ADDENDUM NO. 2

PROJECT:	Dexter High School Twin Turf Fields Restroom Building
OWNER:	Dexter Community Schools
LANDSCAPE ARCHITECT/ ENGINEER:	Beckett & Raeder, Inc. 535 W. William, Suite 101 Ann Arbor, MI 48103
DATE:	October 14, 2025
BID DUE DATE:	October 20, 2025 – 1 p.m. (unchanged)

C6.2

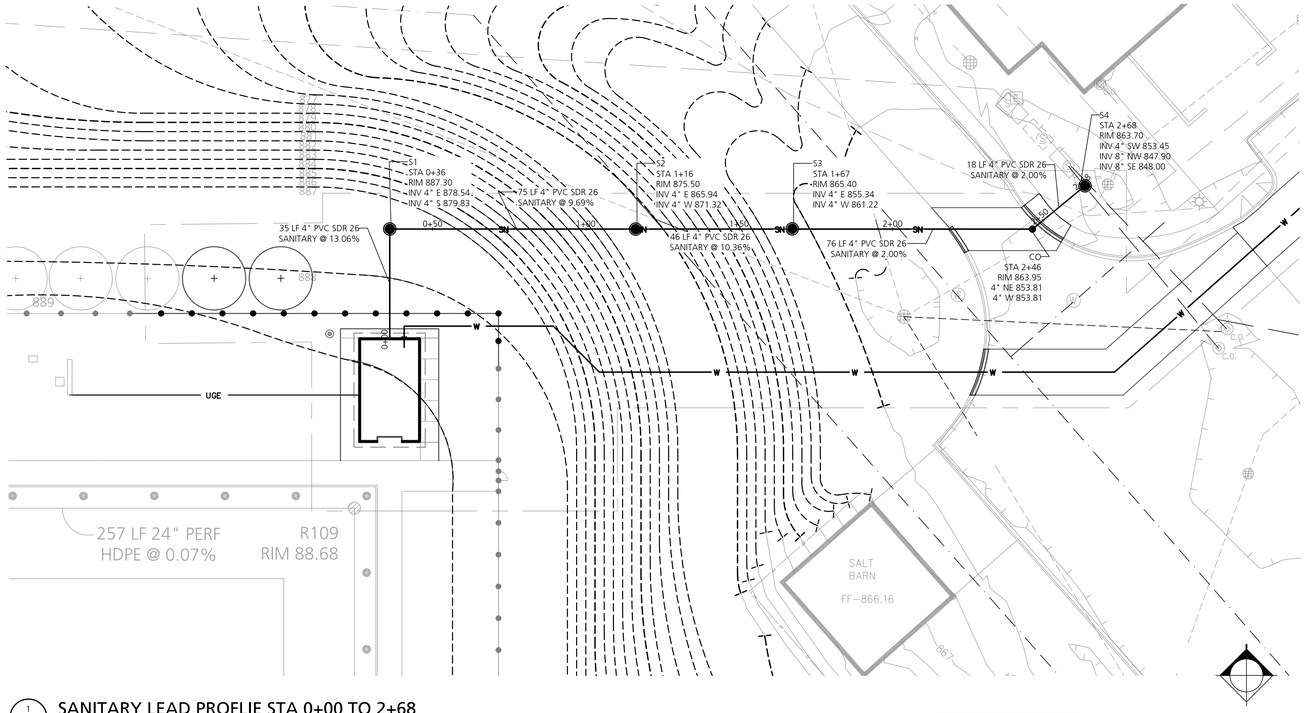
1. C6.2 – Utility & Restoration Plan (re-issued)
   a. Clarified sanitary sewer structures and inverts.
2. C6.7 – Sanitary Plan & Profile (new issuance)
   a. Added sanitary sewer plan & profile for clarification of sewer structures and inverts.
3. E-004 – Electrical Site New Work Plan (re-issued)
   a. Clarified routing of feeder to RP-2.
4. E-501 – One Line Diagram, Panel Schedules, Electrical Details & Diagrams (re-issued)
   a. Clarified electrical feed to RP-2.
   b. Removed RP-1 panel schedule.

Q: *Upon review, we noticed that the sanitary structure schedule lists four structures, but only three appear to be shown on the drawings. Could you please confirm if there's any additional information or clarification available on this?*

A: Please refer to clarified sanitary sewer plan and profiles issued with this Addendum 2.

ONE LINE DIAGRAM
NO SCALE

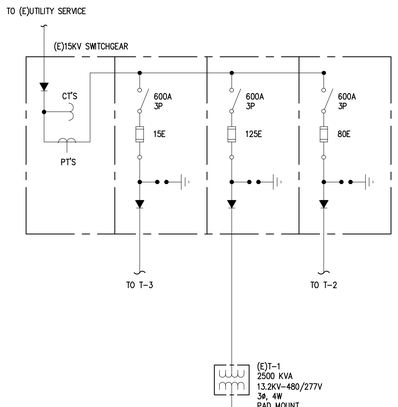
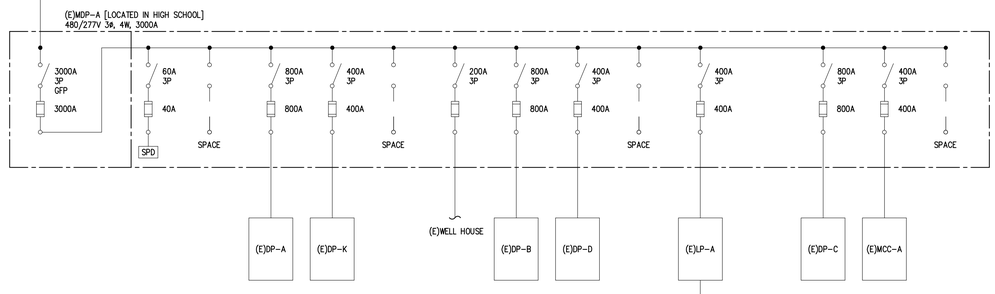
Q: *Sheet E004 and sheet E501- One line diagram is indicating that we are to supply the new electrical panel (RP-2) with 150A three phase power from the existing panel RP-1. I have spoken with a supplier of our and they have indicated that Eaton does not provide a 150 three pole breaker for the existing panel (RP-1). The largest that they have is a 100A three pole. Either everything can be reduced to 100A, or we can find another source to feed the RR building. If there is any space available in the existing LP-A field lighting panel (480V three phase), this could be the source to a step-down transformer at the RR building. Please have this confirmed.*

A: Please refer to revised power feeds issued with this Addendum 2.
